**Planning Commission
Staff Report
January 19, 2017**

Case No.	16ZONE1057
Project Name	Tri-Village Storage
Location	1170 E. Broadway
Owner(s)	Eagle Properties, Inc. Louisville Broadway Apartments LLC
Applicant	Brexton LLC
Representative	Bardenwerper Talbott & Roberts PLLC
Project Area/Size	0.213 acres
Jurisdiction	Louisville Metro
Council District	4 – Barbara Sexton Smith
Case Manager	Beth Jones, AICP, Planner II

Land Development & Transportation Committee
Staff Report
December 20, 2016

**Zone Change Pre-Application
Staff Report
September 23, 2016**

16ZONE1057
TRI-VILLAGE STORAGE
1170 E. BROADWAY
ZONE PLAN
LOUISVILLE BROADWAY APT. LLC
US 150

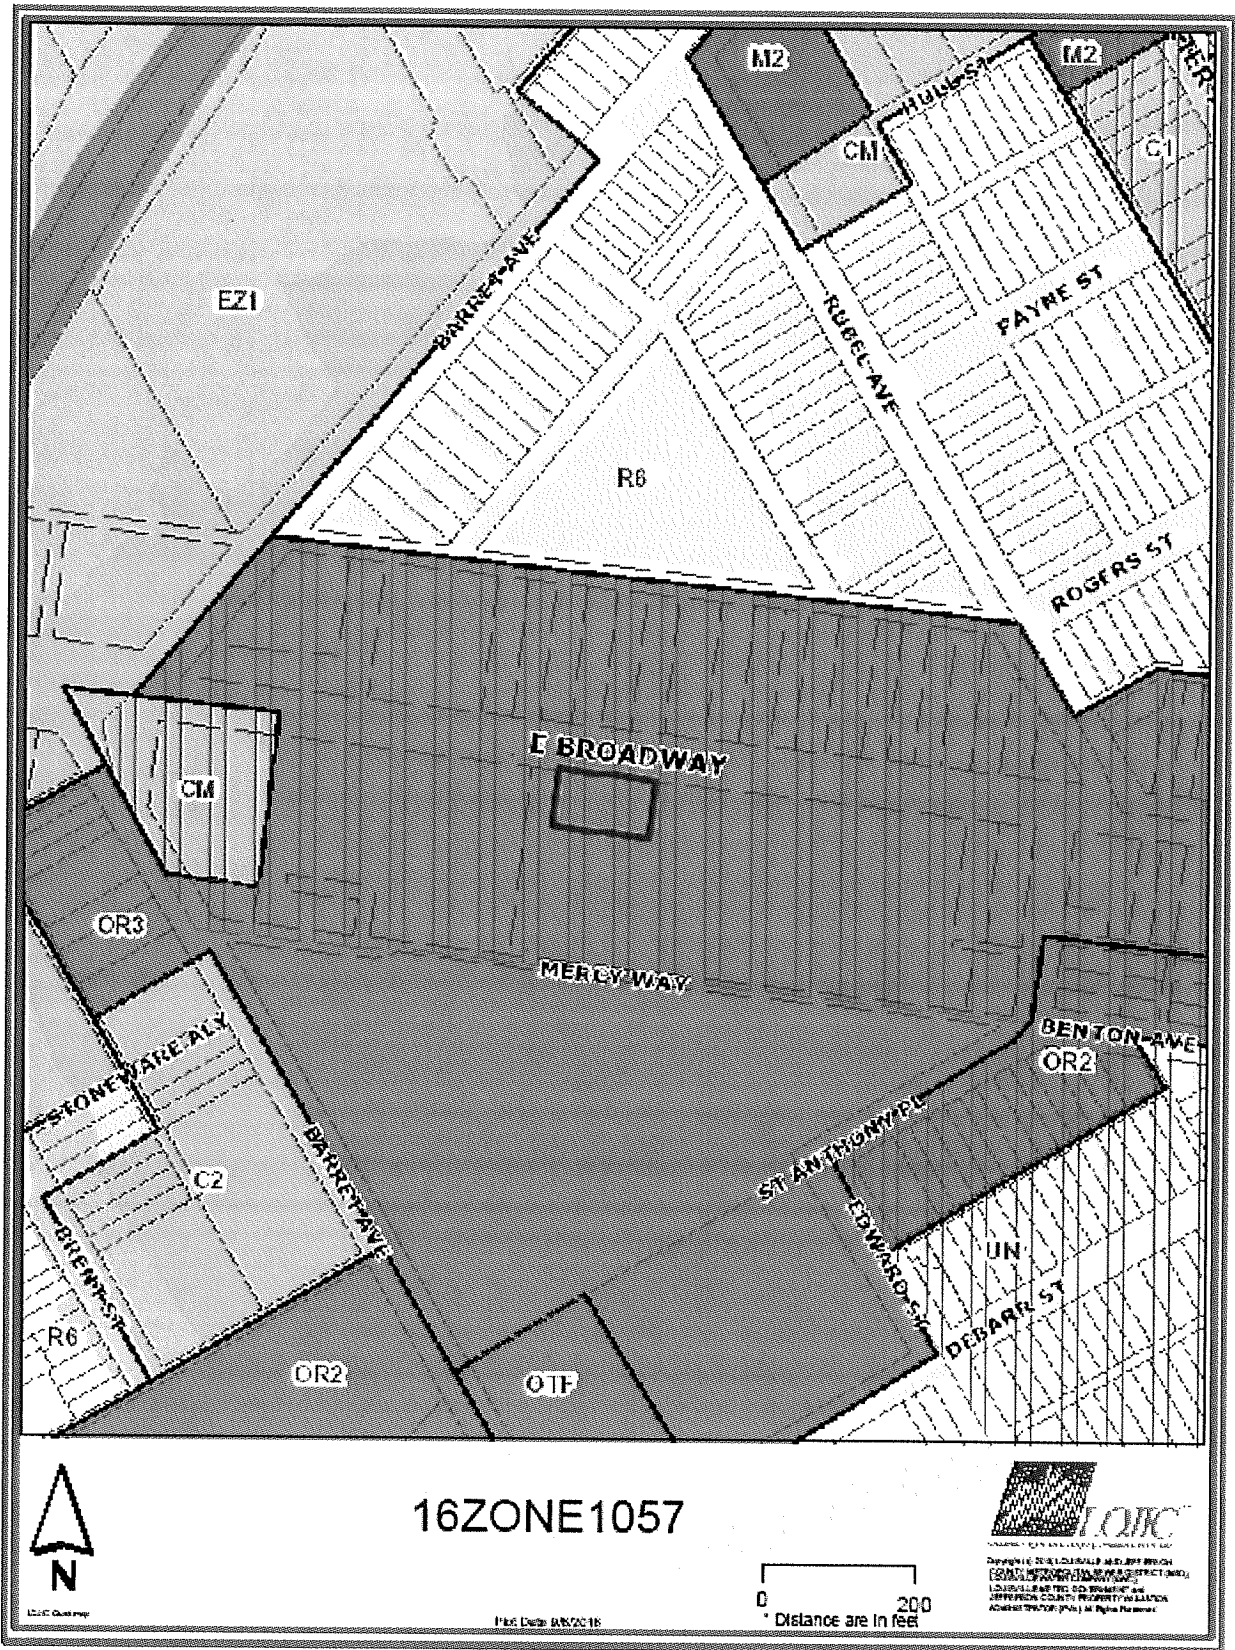
1. Additional right of way may be required across the frontage of this tract to meet the current Metro Land Development Code. The requirements are determined by Louisville Metro Transportation Planning and Public Works departments.

2. Calculations will be required for any runoff deemed necessary to be taken to the state right of way. Proposals to alter or significantly increase a drainage area or runoff factors or to change in any way the performance of an existing drainage structure shall be accompanied by a complete drainage survey and hydrologic analysis (upstream and downstream) based on 25-year and 100-year storms. This analysis shall include a comparison of existing and proposed conditions. Requests to alter drainage on a right of way shall result in conditions that are equal to or better than the existing facilities.

3. There should be no commercial signs on the right of way.
4. There should be no landscaping in the right of way without an encroachment permit. Landscaping on plans will need to be reviewed for site distance.

9. Traffic study may be required.
11. KYTC is okay with the concept on the Zone plan except for comments in this review. This is just a preliminary approval. KYTC will review again if or when construction plans are submitted, and reserve the right to change or qualify the approval when construction plans are submitted for review
